Re: Site Plan Application for Restaurant with Accessory Brewing Operations and Tap Room
873 Holding Company LLC
Premises: 873 North Broadway, North Castle, NY 10603 (122.12-4-27)

Responses to Town Staff and Planning Consultant Memorandum

Town of North Castle Planning Department Staff Report, dated October 1, 2021

Kellard Sessions Memorandum, dated October 8, 2021

LAYOUT AND LANDSCAPE PLAN
1" = 20'

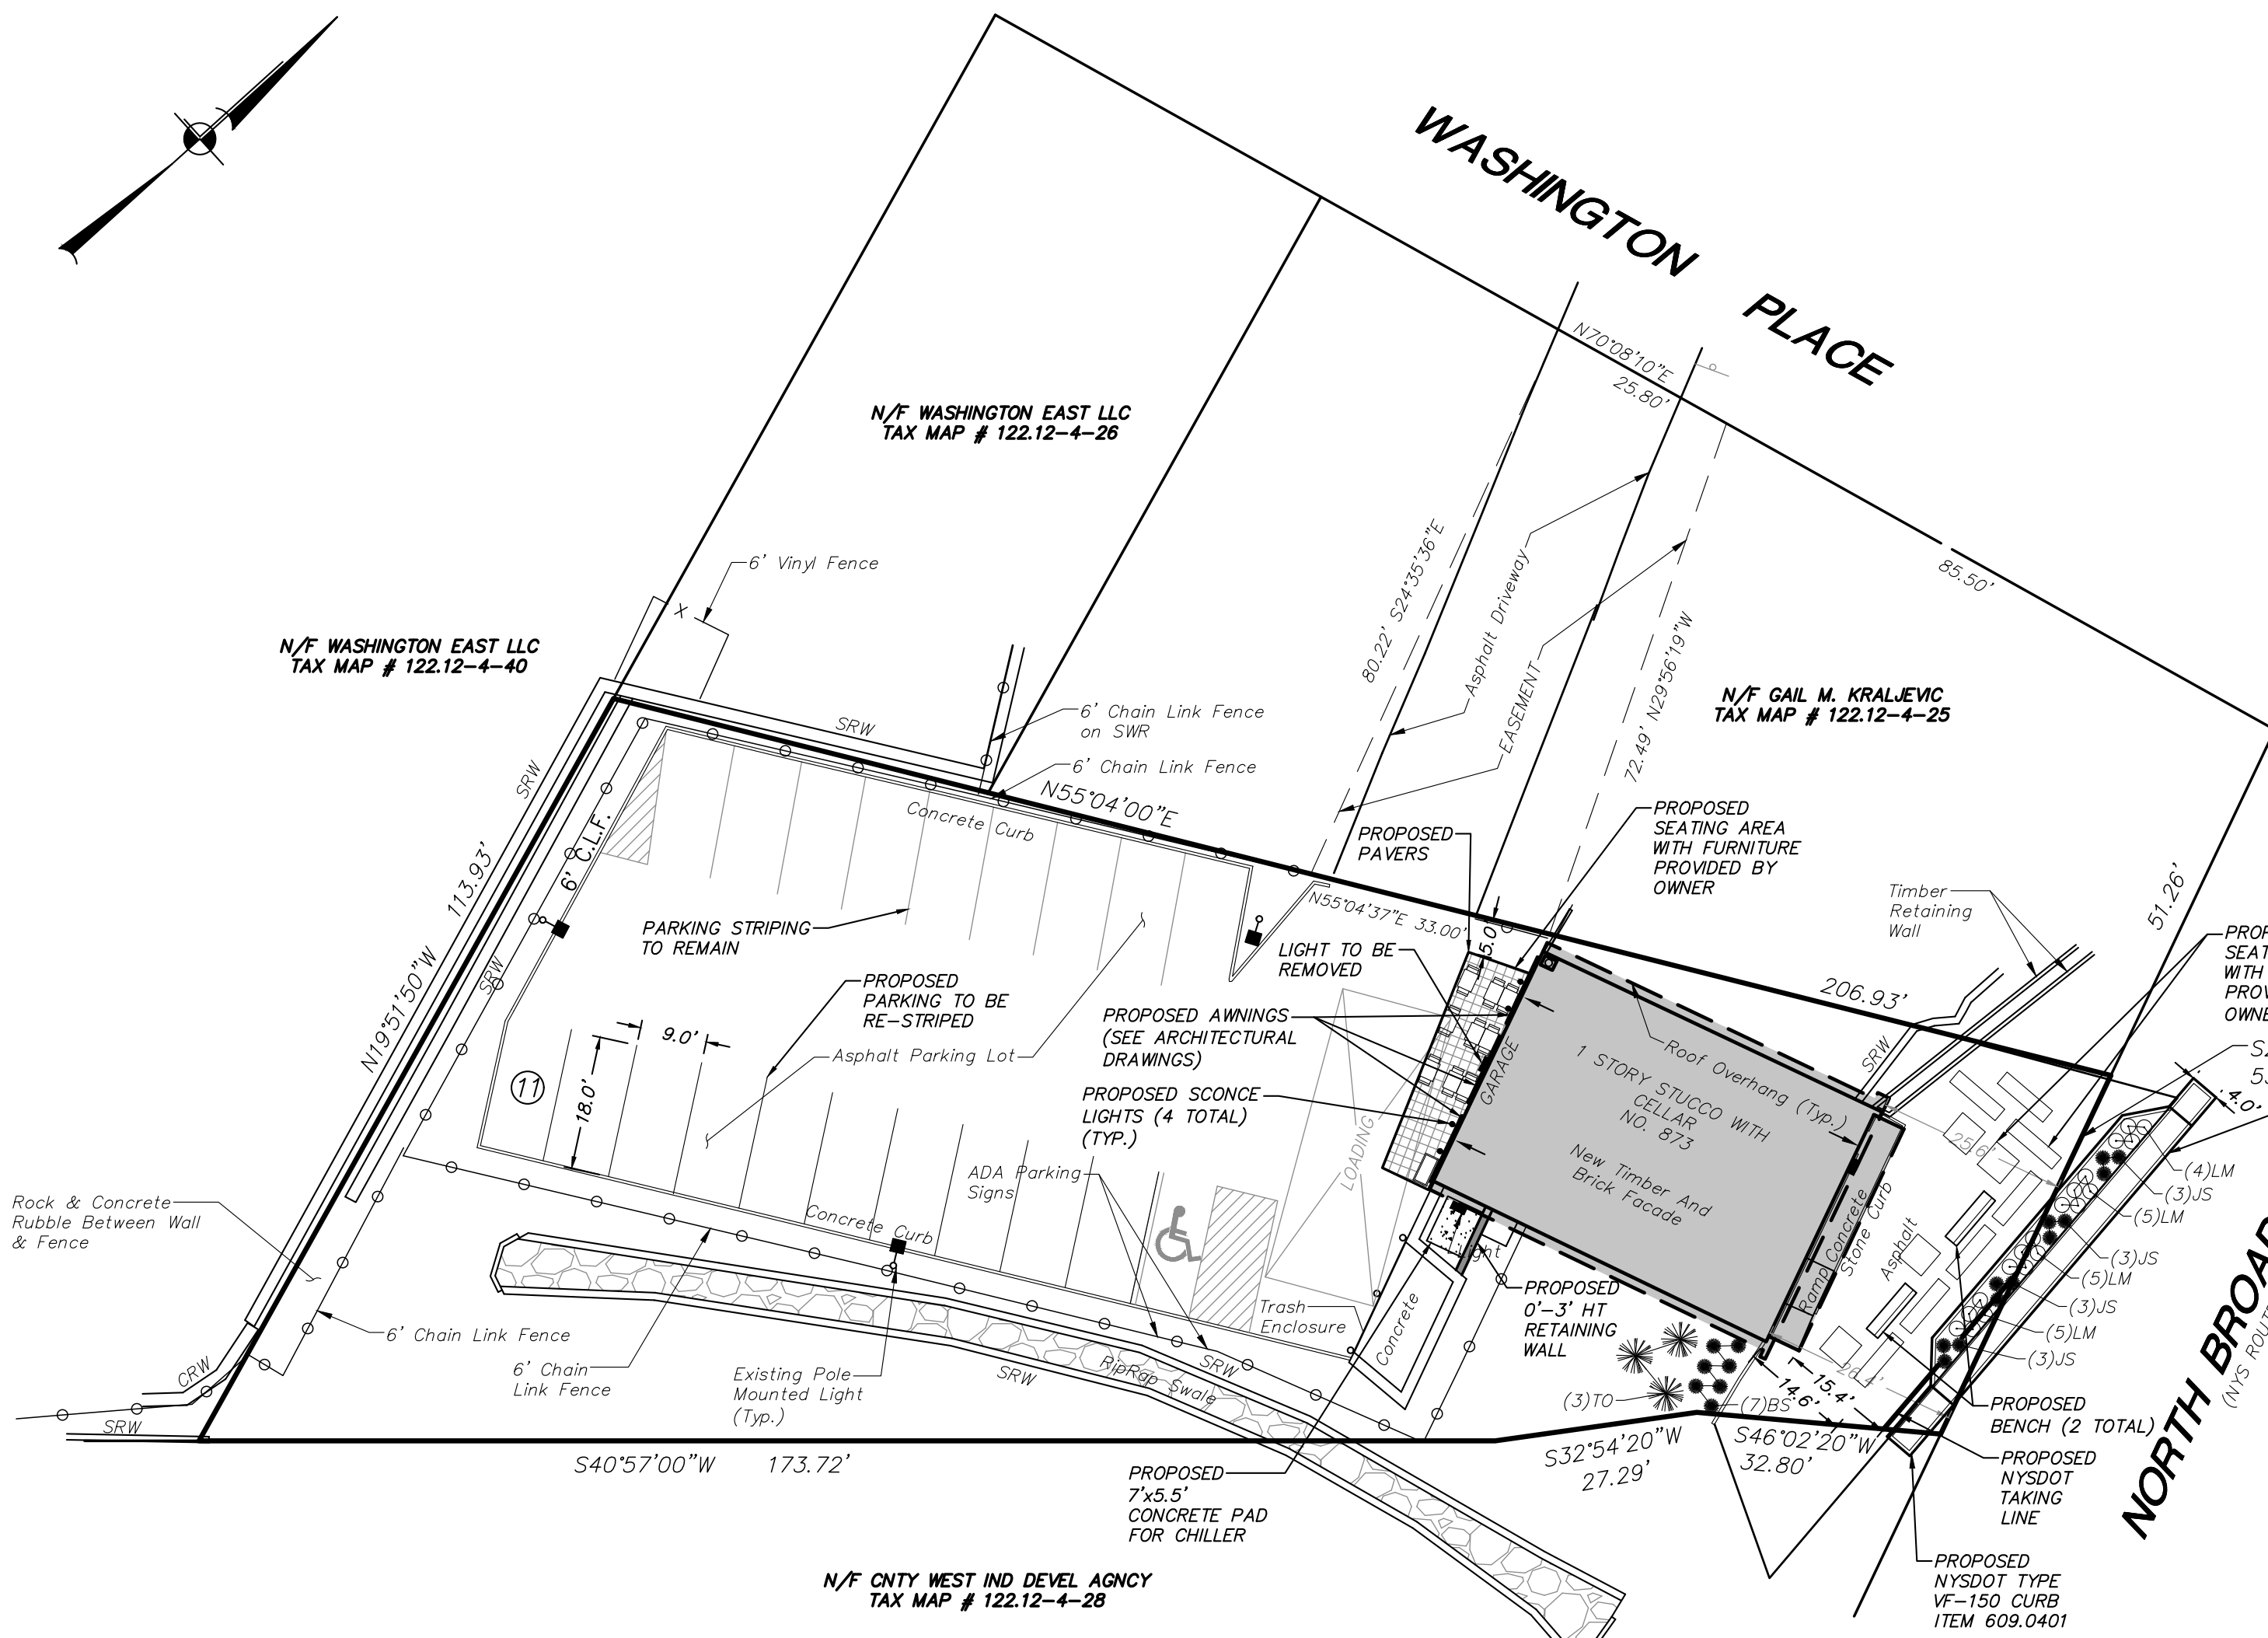
3. The previously approved parking lot contained a total of 20 off-street parking spaces, while the submitted site plan depicts 21 spaces. The site plan should be revised to depict the dimensions of the parking spaces and explain how the off-street parking count was increased as compared to the previously approved site plan.

7. Pursuant to Section 355-15 of the Town Code, the outdoor dining terraces should not be located closer than 5 feet to any property line. The site plan should be revised to demonstrate conformance with this section of the Town Code.

9. The site plan should dimension the edge of the roof overhang fronting N. Broadway to the edge of the NYSDOT taking area. The distance from the roof to the new front property line should not be less than 10 feet.

11. The site plan should be revised to depict the location of a trash enclosure and include a detail. The Applicant should demonstrate that the trash enclosure is large enough to accommodate the waste and recycling needs of the proposed uses on the site.

Response: The site plans have been revised to depict 20 total parking spaces. The previously submitted plans were reflective of the existing parking lot conditions, which were incorrectly striped. The parking on the south side of the lot is proposed to be re-striped with 9' x 18' parking spaces as shown in the previously approved plans.

Response: The outside seating area has been reconfigured and is no longer proposed within 5 feet of any property line.

Response: Since the last Planning Board meeting Applicant's engineers have been in contact with NYSDOT. The NYSDOT has asked the Applicant to shift the taking line so less property will be given to NYSDOT. The plans have been revised to reflect the NYSDOT request. The drawings have been updated to dimension the distance from the overhang to the proposed property line. The dimension from the roof to the new front property line will be 15.4'.

Response: The site plans have been updated to identify the existing trash enclosure which will be utilized for the proposed use. The enclosure is 8' x 16' and can accommodate refuse enclosures that are able to meet the demand of the proposed use. The frequency of pick up will be adjusted to accommodate the needs of the restaurant but is expected to be 3-4 times per week. A private carting service will be used.

VALET PARKING PLAN
1" = 20'

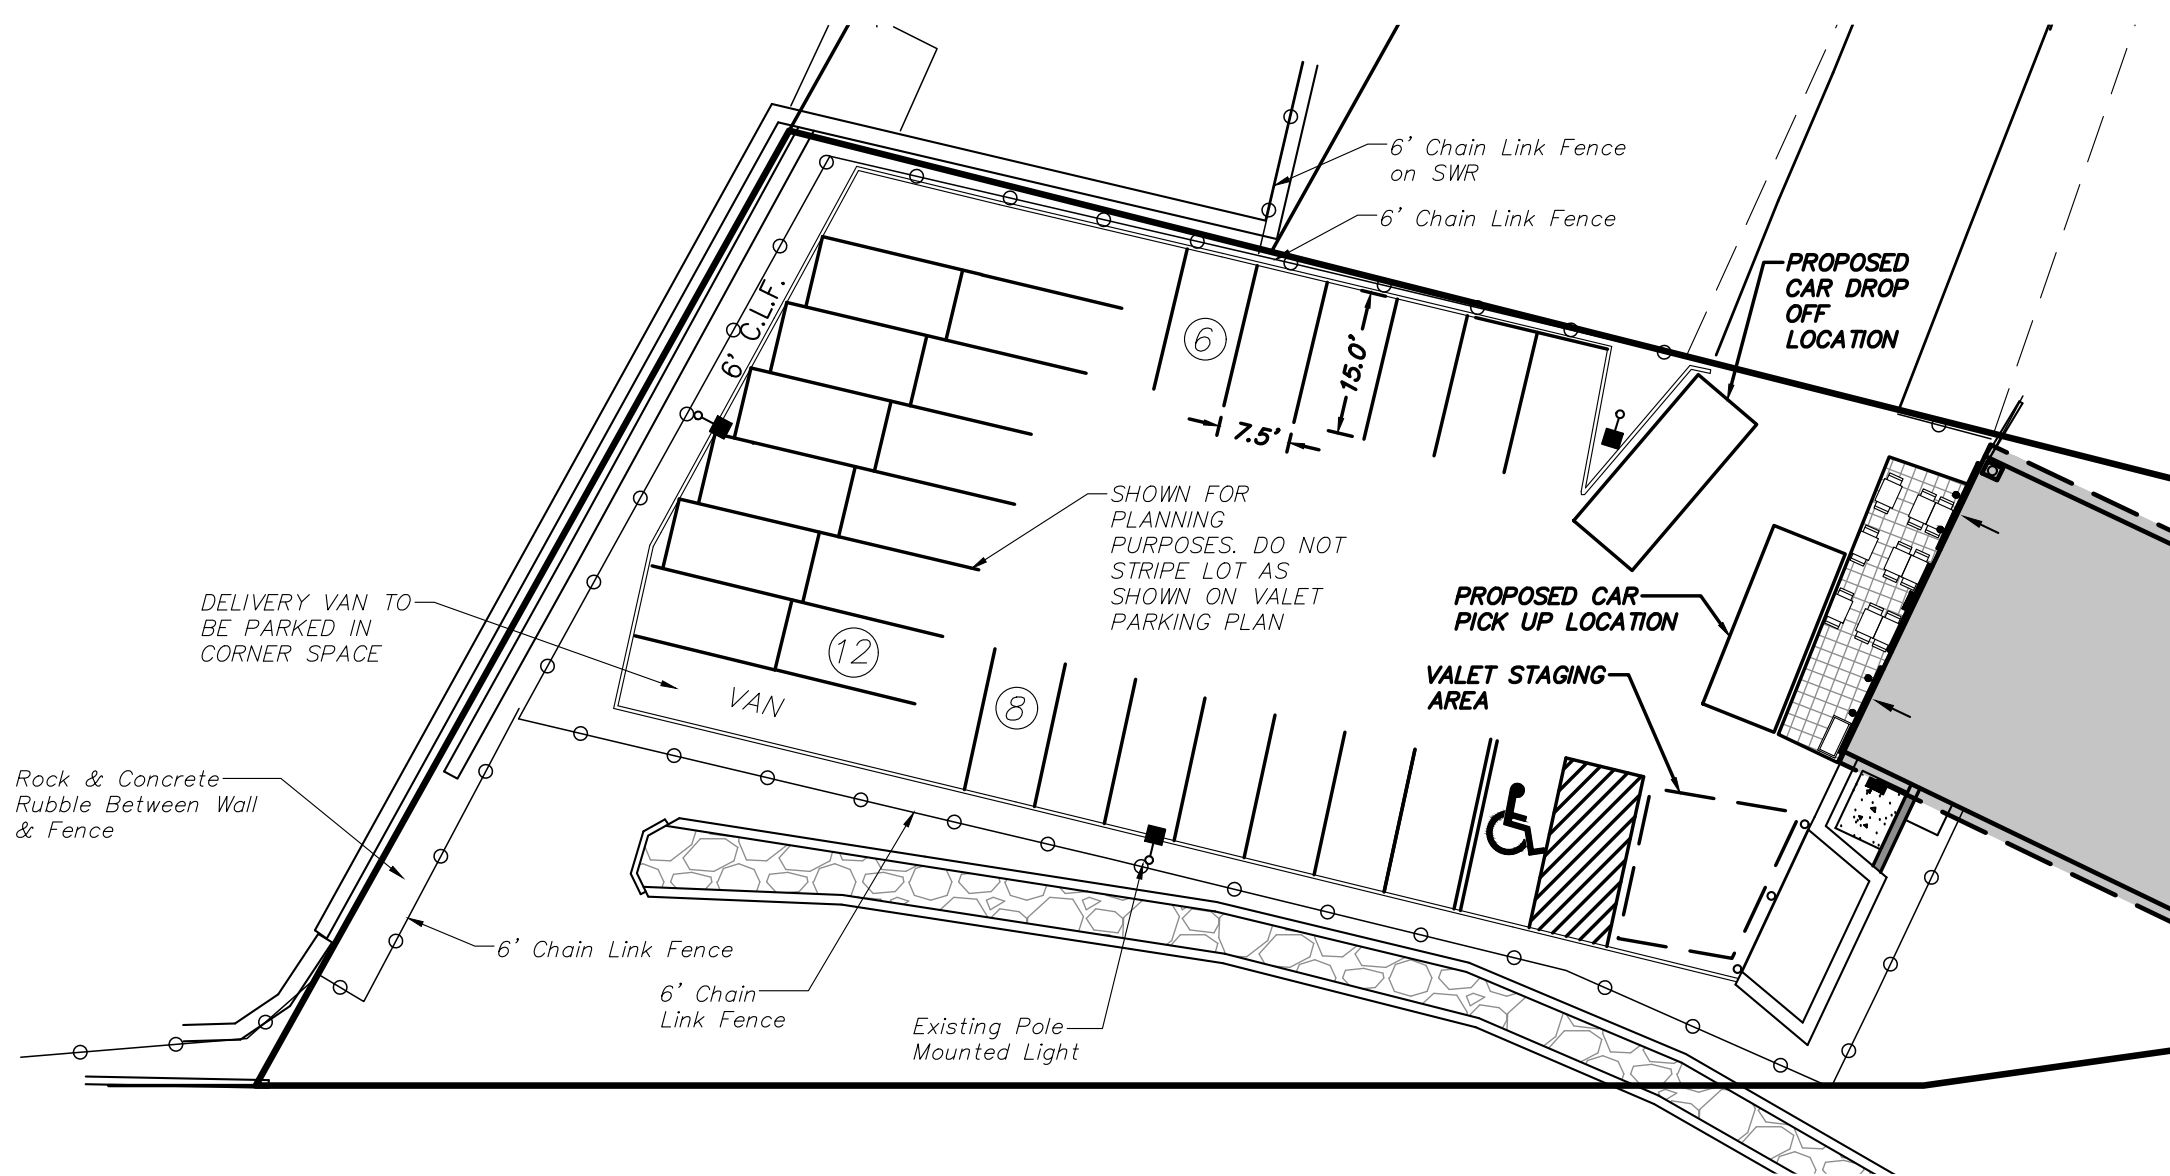
2. The site plan depicts a total of 21 off-street parking spaces where 46 are required. The Applicant will need to obtain an off-street parking variance from the Zoning Board of Appeals.

A valet service also will be provided for onsite parking during the operation of the upstairs dining area. A conceptual valet parking layout plan is included with this submission depicting how the valet can arrange guests' vehicles to enable at least 27 parking spaces. A team of at least two designated valet staff will be employed to ensure that cars are expeditiously ported to and from the parking area to eliminate potential queuing.

Response: The site plans have been updated to depict 20 off street parking spaces. The Applicant anticipates seeking area variance relief for the parking deficiency of 26 spaces. However, the Applicant respectfully submits that using available offsite parking and the proposed valet plan as detailed above there will be sufficient parking provided for the operation of the site.

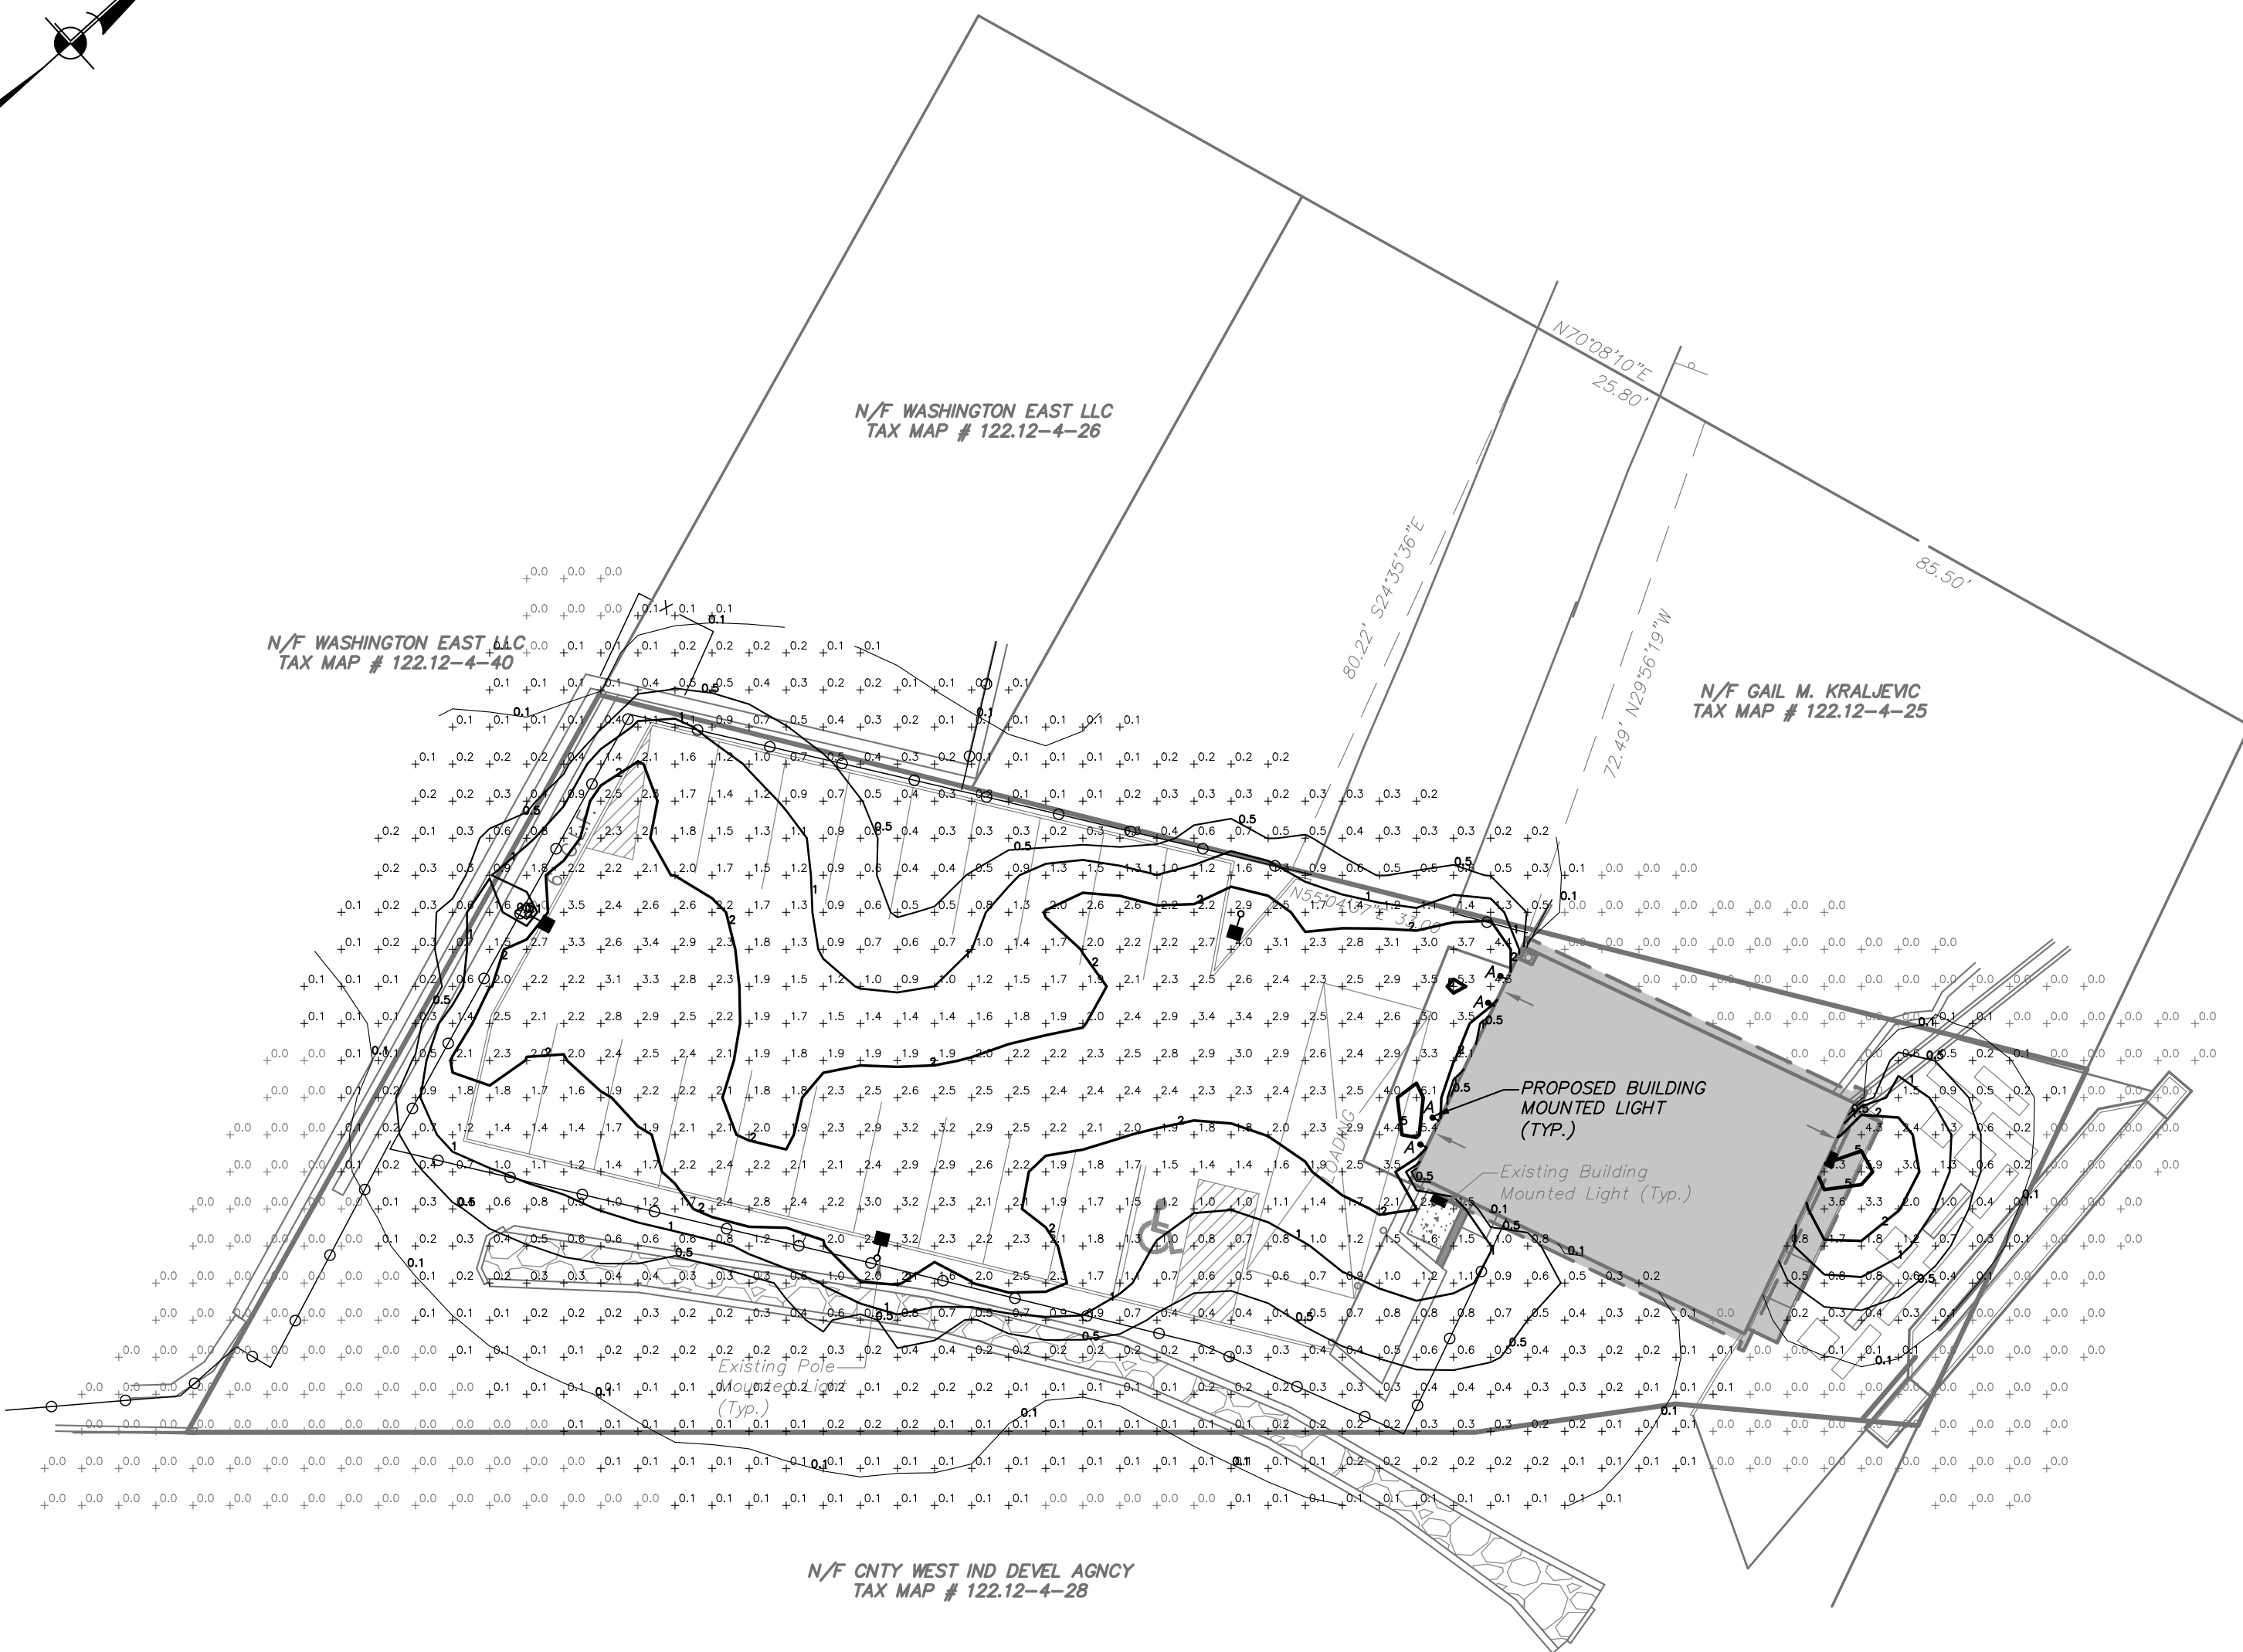
12. The Applicant should submit a lighting plan for review. The plan should include any lighting proposed for the outdoor dining areas.

Response: The drawings have been updated to include a lighting plan for the project site (See Page LP-1).
